PROJECT MEMORANDUM

TO: Members of the Carbon County Planning Board
FROM: Forrest J. Mandeville, AICP – Contract Planner
DATE: November 4, 2022
RE: 7D Subdivision Preliminary Plat Application and Variance Request from Fire Protection Design Standards–Staff Report and Findings

PRELIMINARY PLAT
7D SUBDIVISION
A MAJOR SUBDIVISION LOCATED IN THE SE1/4M OF
SECTION 16, T.7S., R.20E., P.M.M.,
CARBON COUNTY, MT

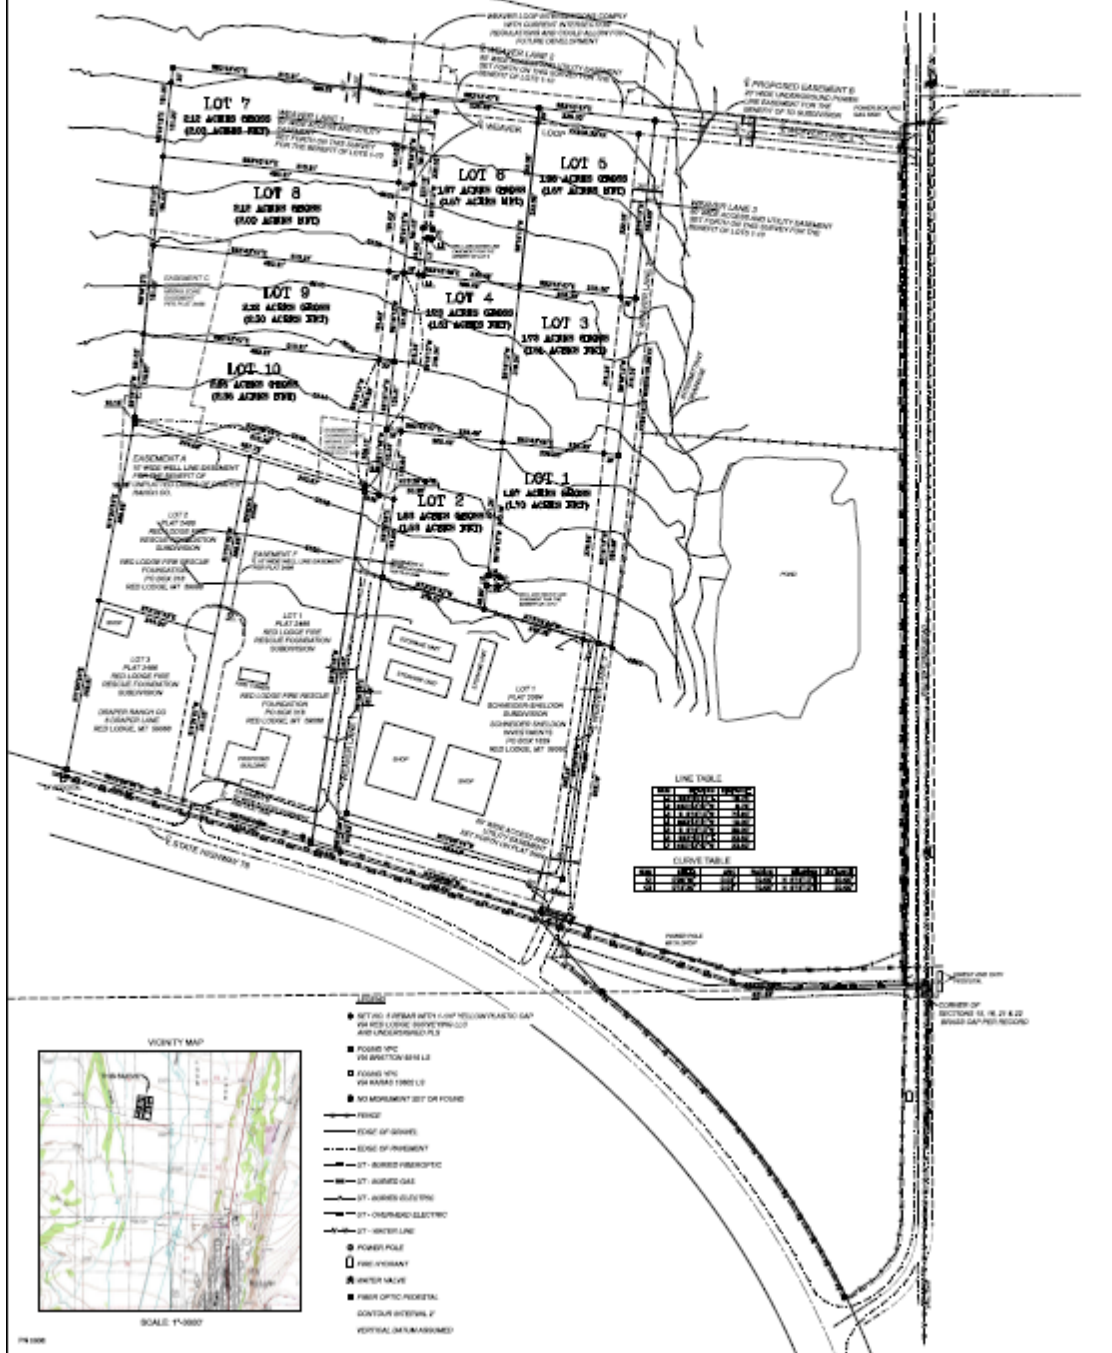
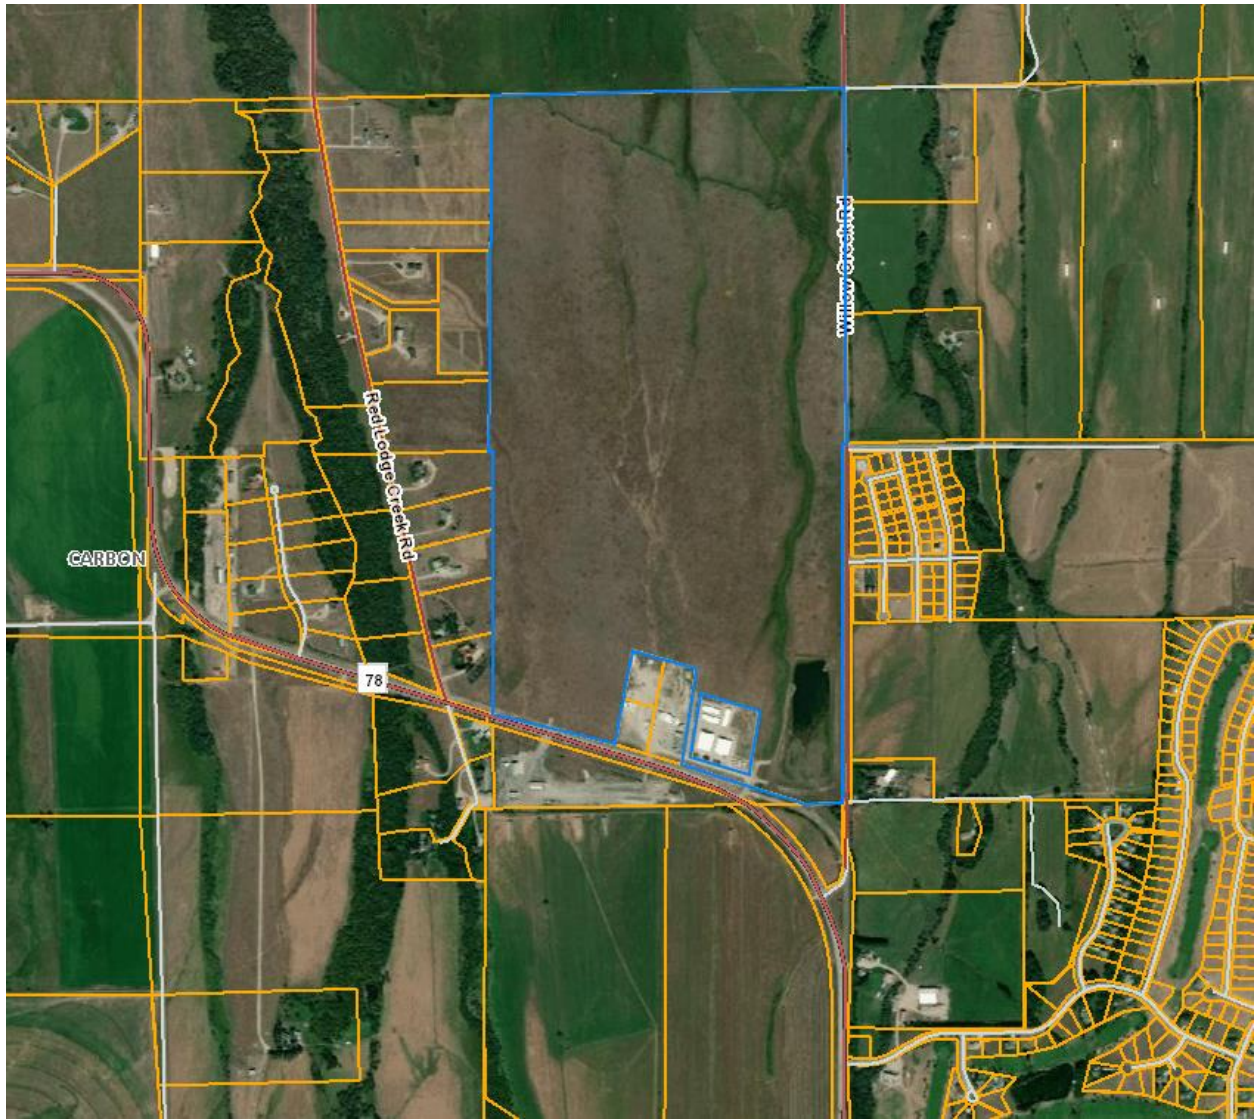
Road names for the new internal subdivision roads are shown on the plat as Weaver Lane 1, Weaver Lane 2, and Weaver Lane 3. These will need to be approved by the County GIS Department and approved names shown on the final plat (Section V-A-10.a.xiii). A conversation with Tom Kohley, Carbon County GIS Coordinator, indicated the preferred option would be three unique road names; two running north and south and one for the east and west road.

Road names for the new internal subdivision roads are shown on the plat as Weaver Lane 1, Weaver Lane 2, and Weaver Lane 3. These will need to be approved by the County GIS Department and approved names shown on the final plat (Section V-A-10.a.xiii). See also discussion and finding under effects on local services.

- i. The Montana Subdivision and Platting Act: The Plat has been prepared and processed in accordance with the Montana Subdivision and Platting Act (MSPA). The final plat should include a notation that each lot has legal and physical access (76-3-608(3)(d), MCA, and Section III-B-11.g.v of the Carbon County Subdivision Regulations).

5. Road names shall be approved by the Carbon County GIS Department. Approved names shall be shown on the final plat. (Section V-A-10.a.xiii; Effect on Local Services)

12. A notation shall be provided on the final plat that legal and physical access is provided per 76-3-608(3)(d), MCA. (Section III-B-11.g.v; Compliance with the Montana Subdivision and Platting Act)
